# CITY OF ALBUQUERQUE

**Re: The 66**  
**4501 Central Ave. NE**  
**Traffic Circulation Layout**  
Architect's Stamp 03-06-23 (K17-D125)

Based upon the information provided in your submittal received 10-26-23, the above referenced plan cannot be approved for Building Permit until the following comments are addressed:

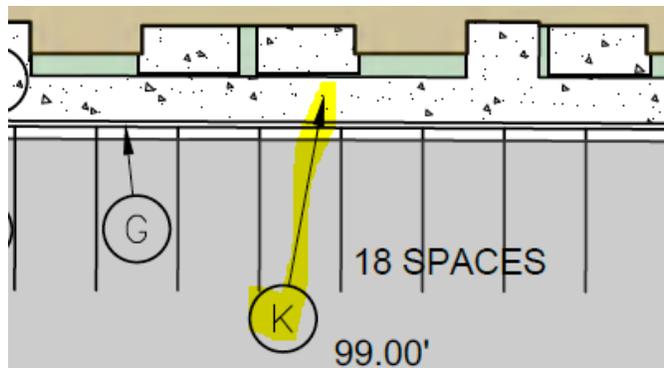
1. Identify all existing easements.
2. Proposed Site access off Central Ave.:
  - please provide width and show the radii on the site plan.
  - Minimum throat depth should be 50 ft. please show this dimension on the site plan.
3. Proposed Site access off Copper Ave:
  - Provide width and show the radii on the site plan.
  - Please show on the site plan a vehicle turnaround template to ensure there will be no backup to the public right of way.
4. Key note X: A minimum 4 ft. wide pedestrian path should be shown around each of the poles; please show these dimensions on the site plan to ensure that a minimum 4 ft. wide path is obtained.
5. Please show main entrance and the doors way.
6. Please revise site plan, key note K refer to curb and gutter.

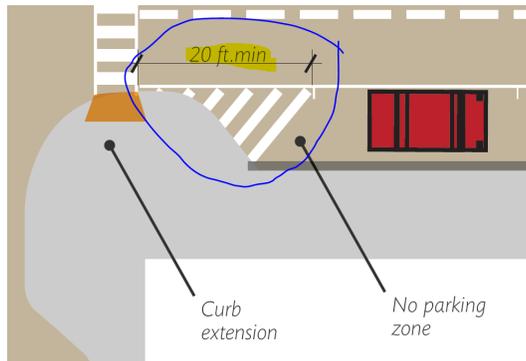
7. Please explain, what is this?

**SITE PLAN**

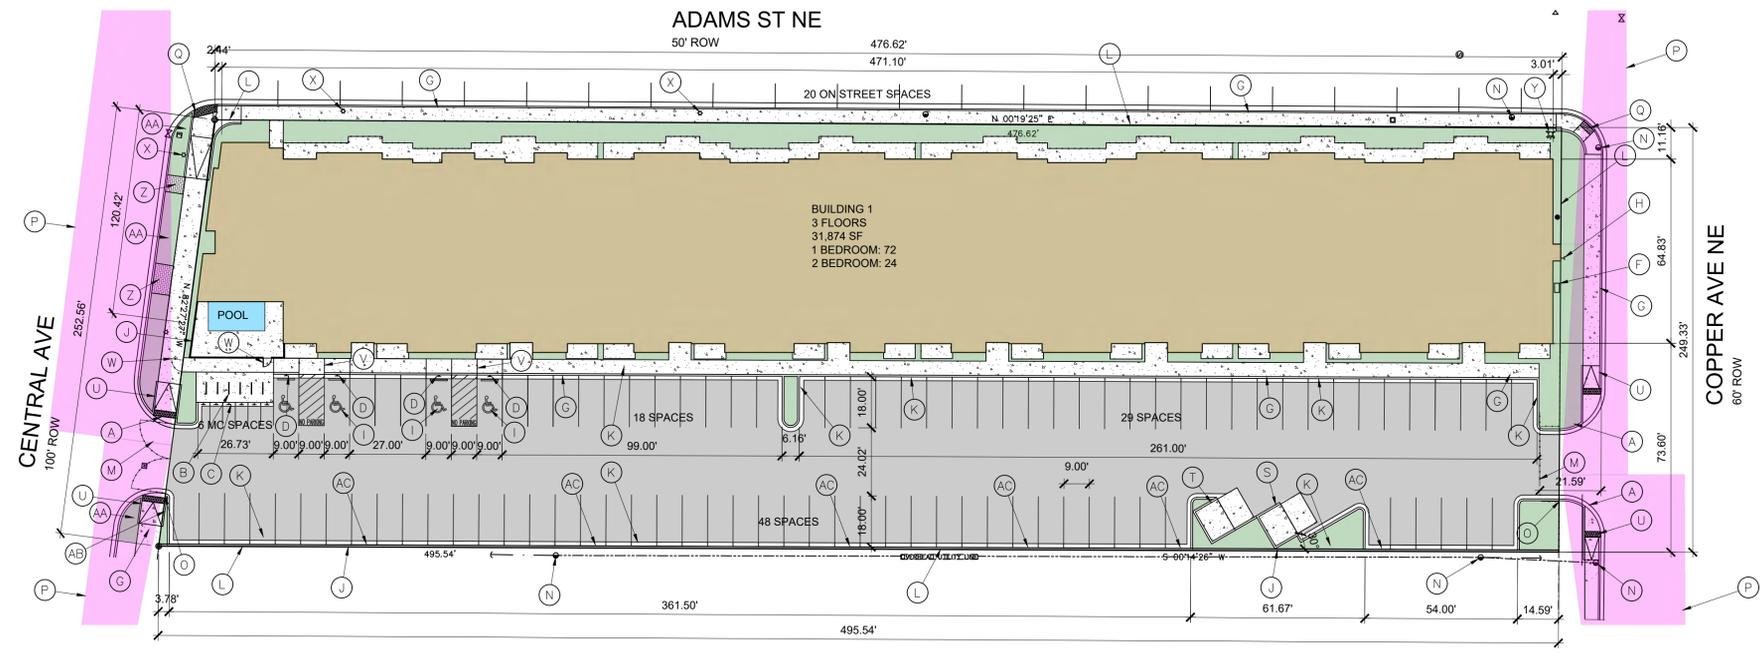
8. Please show on the site plan a minimum 20 ft. long no parking zone on Adams St. at the corner of Adams St. & Central Ave. and Adams St. & Copper Ave.

9. The pavement marking "MC" should be shown in the opposite direction for motorcycles entering the parking space.
10. All one-way drives shall have "One Way" and "Do Not Enter" signage and pavement markings. Please show detail and location of posted signs and striping.
11. Please show legend on the site plan.
12. Unused curb cuts must be replaced with sidewalk and curb & gutter. A build note must be provided referring to the appropriate City Standard drawing.
13. Please provide a letter of response for all comments given.
- Once corrections are complete resubmit
1. The Traffic Circulation Layout
  2. A Drainage Transportation Information Sheet (DTIS)
  3. Send an electronic copy of your submittal to [PLNDRS@cabq.gov](mailto:PLNDRS@cabq.gov).
  4. The \$75 re-submittal fee.
